SHOWING PROPOSED BUNGALOW

ON PLOT N^o 9/6 SHEET J.M. 3

THE COSMOPOLITAN CO-OPERATIVE

HOUSING SOCIETY LTD.

SECTION ON C.D.

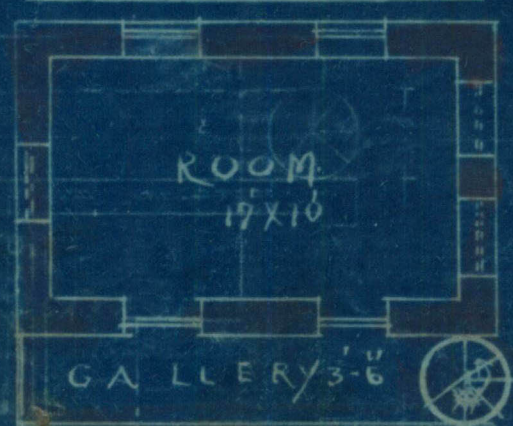
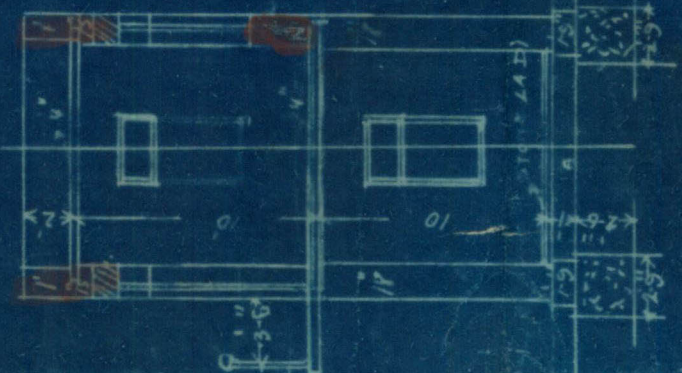
1) The level line is drawn through the existing portion and the portion proposed construction on 1st floor and so a portion of it is shown red in section.

- (1) *10' space must be left from the sides.*
- (2) *The section line is wrongly shown.*
- (3)
- (4)
- (5)
- (6)
- (7)
- (8)
- (9)

3) Regarding the level 10' from the side the architect argues that the garage has already been sanctioned and so they are going to level 10'.
